Exhibit: Existing Conditions: 1636 Argonne Place NW

Front: Existing Grade (Construction Drawings and Photos)

Rear: Existing and Proposed Grade (Construction Drawings)

Revised Plans - Dimensions of Front Entryway 7' 1 1/4" wide - A0100 (12/17/14)	Architect's Photo – Mis-measured from Elevated Curb and Top of Measure Does Not Extend to Ceiling of LL

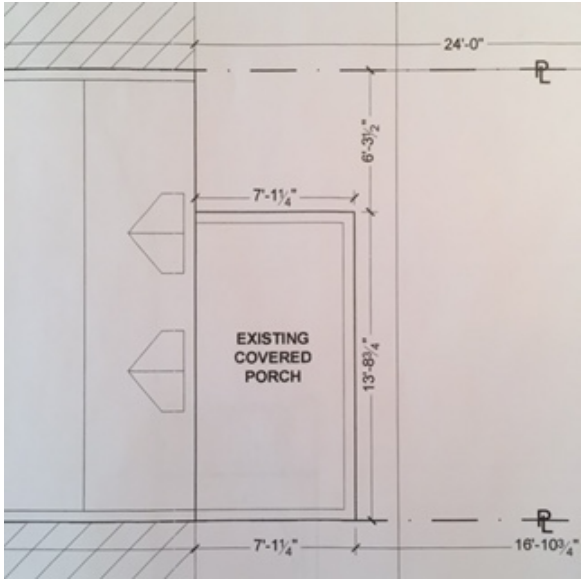
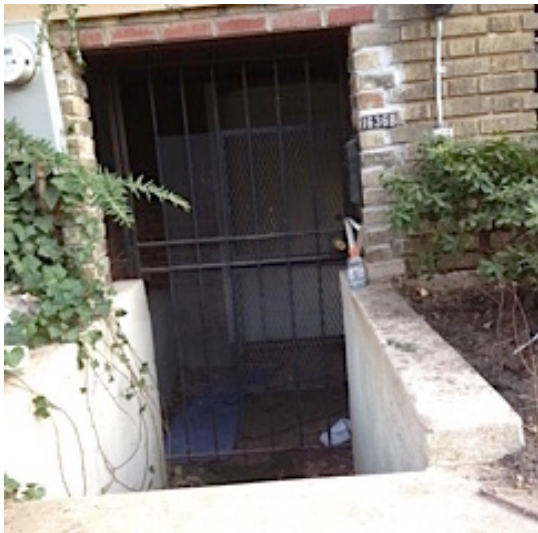
Appellants' Photo Evidencing Lower Level Entryway as well as measurement point from architect's photo on top of raised curb.	Appellants' Photo of Additional Distance (~8") from Bottom Lip of Porch to Ceiling of Entryway

Initial Plans - Elevation of Front Façade. Grade From Front Walk to Ceiling of Lower Level is 4'6" AD0201 (06/24/14)

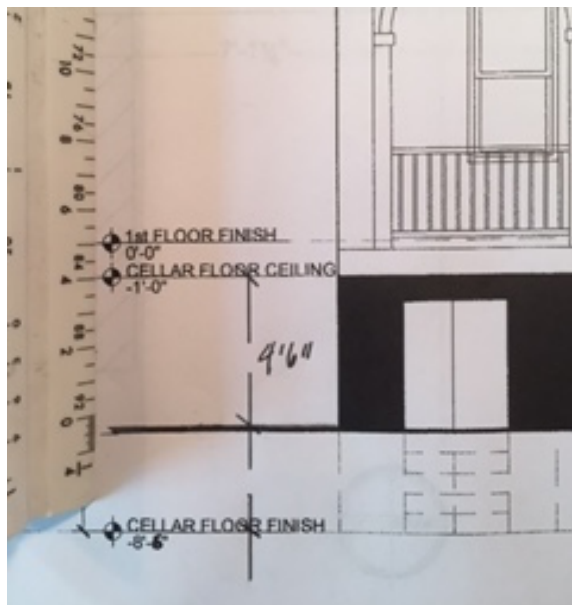
Initial Plans - Elevation of Entryway Misrepresents Existing Grade, which is Actually 8'. A0202 (06/24/14)

Rear Grade: Elevation Drawing Existing and Proposed

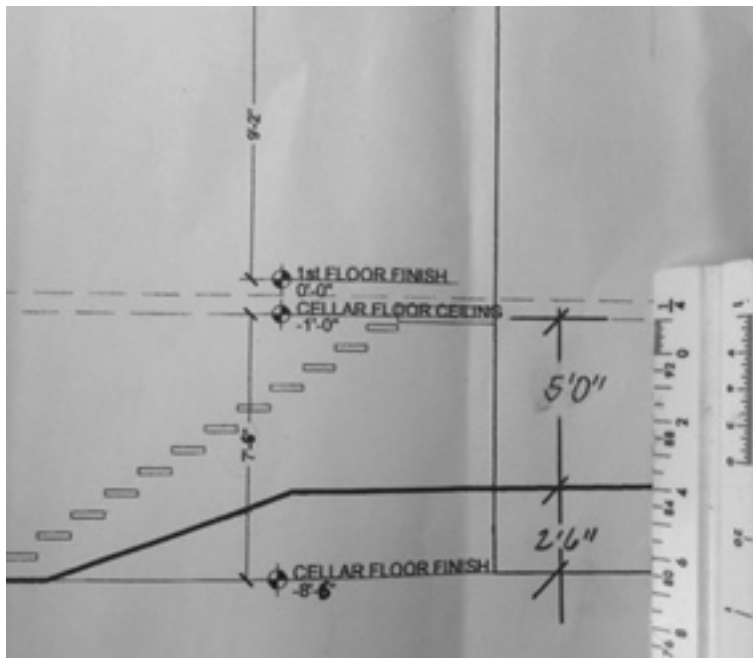
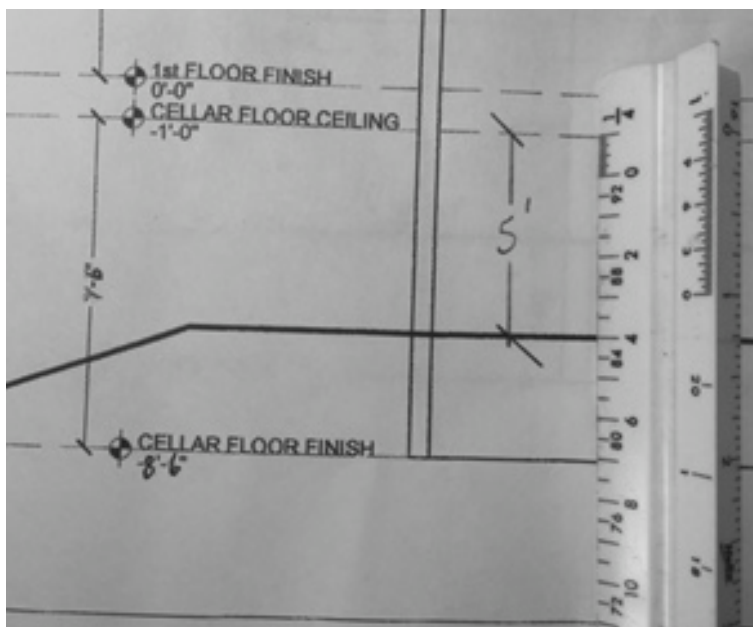
2014 Existing
Depicts Non-
existent grade that
still results in 5'
rear grade
AD0201 (6/24/14)

2014 Proposed
Depicts non-
existing
proposed grade
that still results
in a 5' rear grade
A0201 (6/24/14)

Rear Window Dimensions Revised Plans Do Not Match Actual Installation

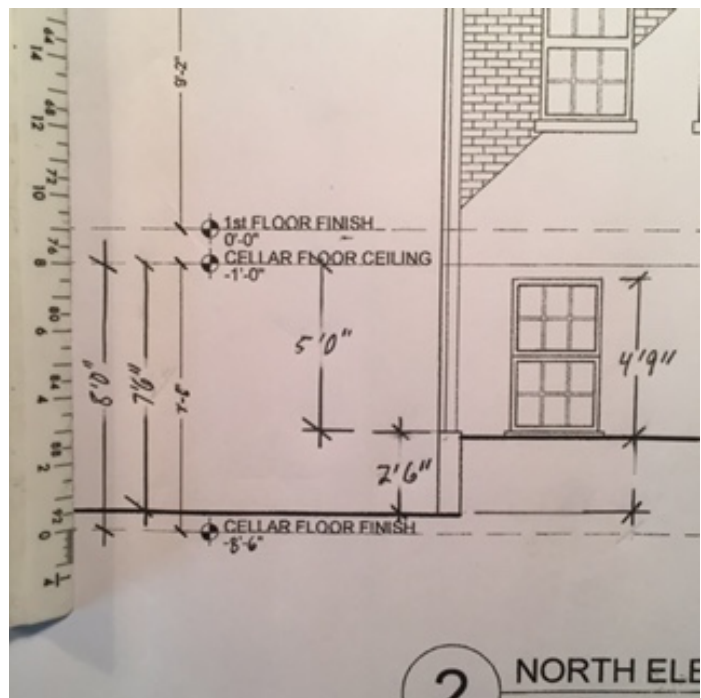
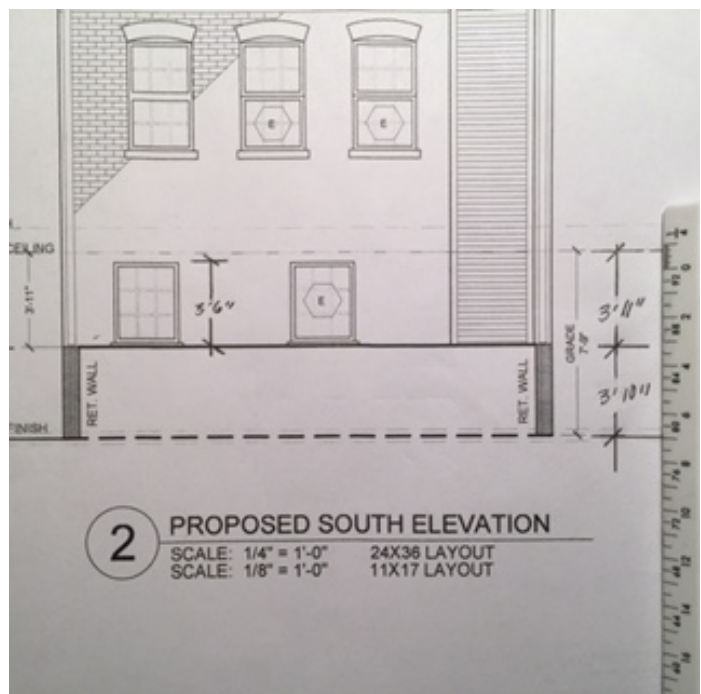
49" Height – Photo Taken 5/4/15

Window Height 4'9"
Initial Plans
A0202 (6/24/14)

Window Height 3'6"
Revised Plans
A0203 (12/17/14)
